APPLICATION NO.	FILING DATE	FIRST NAMED INVENTOR	ATTORNEY DOCKET NO.	CONFIRMATION NO.
10/825,769	04/16/2004	James R. Anthony	2835-74916	8807
23643 7590 01/28/2010 BARNES & THORNBURG LLP 11 SOUTH MERIDIAN INDIANAPOLIS, IN 46204			EXAMINER MACARTHUR, VICTOR L	
			ART UNIT 3679	PAPER NUMBER
			NOTIFICATION DATE 01/28/2010	DELIVERY MODE ELECTRONIC

Office Action Summary	Application No. 10/825,769	Applicant(s) ANTHONY ET AL.	
	Examiner VICTOR MACARTHUR	Art Unit 3679

DETAILED ACTION

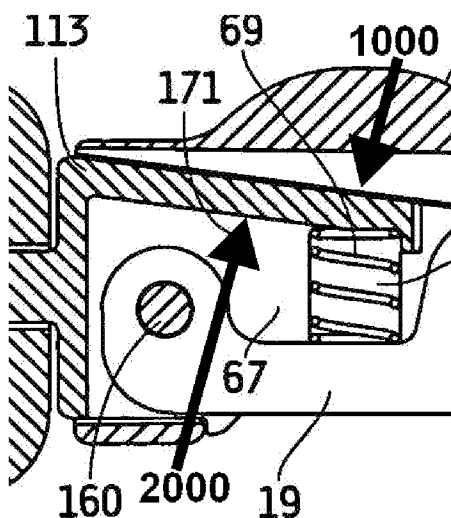
The disclosure is objected to because the specification written description describes applicant's invention in a manner contrary to what is shown in the drawings. More specifically applicant's specification recites a spring 69 that "illustratively acts between top surface 170 of frame assembly 113 and the spring mount or contact portion 117 of lever 114..." (p.16, ll.24-26). Note that as shown in the elected figures applicant's spring 69 does not contact top surface 170. While the recitation technically does not require the spring to contact the top surface or extend therefrom, the phraseology is misleading none the less. See p.3, ll.7-9 of applicant's remarks filed 10/5/2009 wherein applicant attempts to refer to this recitation to overcome the 112 1st paragraph new matter rejection below.

Claims 61-76 are rejected under 35 U.S.C. 112, first paragraph, as containing subject matter which was not described in the specification in such a way as to reasonably convey to one skilled in the relevant art that the inventor(s), at the time the application was filed, had possession of the claimed invention. The claims recite “the biasing member extending between the top surface of the frame and the lever” (last three lines of claim 61). Applicant has not pointed out where the amended claim is supported, nor does there appear to be a written description of the claim limitations in the application as filed such that this newly added limitation constitutes new matter. That is to say that the above limitations are not recited in the application as originally filed. Note that even the present application fails to provide antecedent basis for the terms in the written description. See marked-up version of applicants figure 8A below which clearly shows that applicant’s originally presented biasing member (69) does not contact the top surface (1000) of the frame (113) much less extend therefrom. Rather, the originally presented biasing member (68) extends between an inner surface (2000) of the frame and the lever.

Regarding the new matter rejection of the limitation "the biasing member extending between the top surface of the frame and the lever" (last three lines of claim 61), applicant argues that the specification provides antecedent basis for this limitation by reciting that spring 69 "illustratively acts between top surface 170 of frame assembly 113 and the spring mount or contact portion 117 of lever 114 to urge the lever to the closed position..." This is not persuasive since the written description term "illustratively acts" is not synonymous with "extending between" such that no antecedent basis is provided thereby. Furthermore the written description recitation appears to be an inaccurate description of applicant's invention and should be amended as described in the objection to the specification above.

Further regarding the new matter rejection applicant argues that applicant's top surface 170 should be taken to refer "generally to the top or top wall of the frame assembly 113". This is not persuasive. The terms "surface" and "wall" are not synonymous in scope. A wall is known to have numerous surfaces and not the other way around. That is to say a claim limitation of a

top surface is much narrower in scope than a top wall. In fact, it is clear that applicants claimed biasing member (69) extends from the bottom surface of the top wall of 113, not from the top surface (170). The biasing member (69) does not contact top surface (170) at any point of its normal operation as originally disclosed. If applicant means for the claim to refer generally to top wall of element (113) rather than specifically to top surface (170) than the term "top surface" must be replaced with "wall". The public cannot be expected to assume claimed terms to have meanings contrary to their commonly accepted definitions, much less guess at which contradictory meanings applicant may mean to employ. What other claim terms are meant to have meanings contrary to what the public has commonly accepted? Does applicant intend for all references of "top" in fact to mean "bottom"? Does applicant intend for left to mean right? How should the public go about determining the true intended scope of applicant's claims? Applicant may act as his or her own lexicographer to specifically define a term of a claim by including a written description that clearly sets forth specific special definitions so as to put one reasonably skilled in the art on notice of the true scope of claims. However, applicant is not permitted to use claim terms contrary to their commonly accepted meanings in an effort to gain patentability of a device based on an enigmatic scope that hides the true meaning of claims from the public. *Process Control Corp. v. HydReclaim Corp.*, 190 F.3d 1350, 1357, 52 USPQ2d 1029, 1033 (Fed. Cir. 1999). Currently, the specification has no specific definition for the claim term "top surface" to mean --bottom surface of top wall--, nor would such a contrary definition give fair notice to the public of the true scope of the claims. Why, if not to purposefully confuse the public, would applicant insist on claiming that spring 69 extend from top surface 170, when in fact spring 69 extends from the bottom surface of the top wall of element 113?

Appropriate correction is required. The examiner suggests replacing the phrase "top surface 170" with --top wall of frame assembly 113--.
